November 2022 | Danfoss Climate Solutions for cooling

TECH
INSIDER

ICF 25 with pressure control module (ICFG)

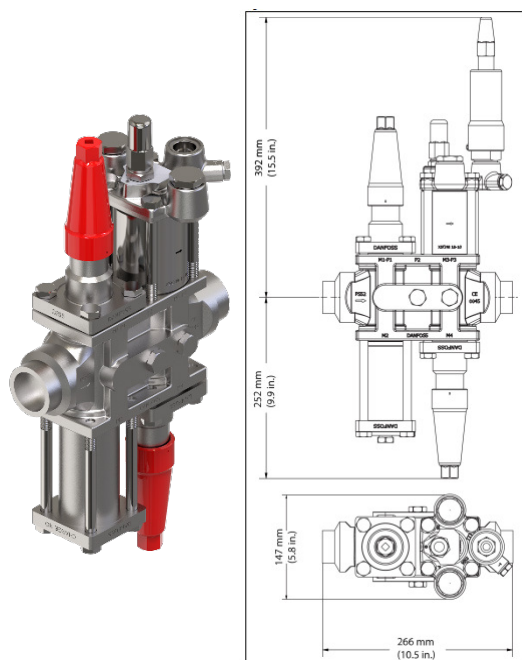
The ICFG module can accommodate all ICS 25 inserts and be configured with pilot arrangements exactly the same as ICS. These new configurations will allow you to cover more applications with ICF, such as evaporator pressure regulator for smaller systems as well as outlet regulators for hot gas feed.

The new configurations released cover ICF 25-4 and 25-6 with multiple connection sizes and multiple selection of ICS 25 inserts on ICFG.

The new variants **without** LON module are:

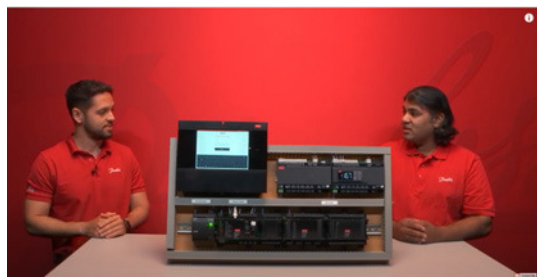
To support this new communication setup and to reduce the dependency on scarce LON modules, new versions of the AK-SM 800A **without** LON module are now also available.

All System Manager 800A Series updated to software version 3.1 or above will be capable of communicating with the new AK-PC 782B. Communication over LON with the AK-PC 782A through the System Manager 800A series remain possible for current variants supporting LON modules. New variants of the AK-SM 800A has now been created without LON modules. These variants will only support the new AK-PC 782B and no longer the AK-PC 782A variant or any other LON based controllers.
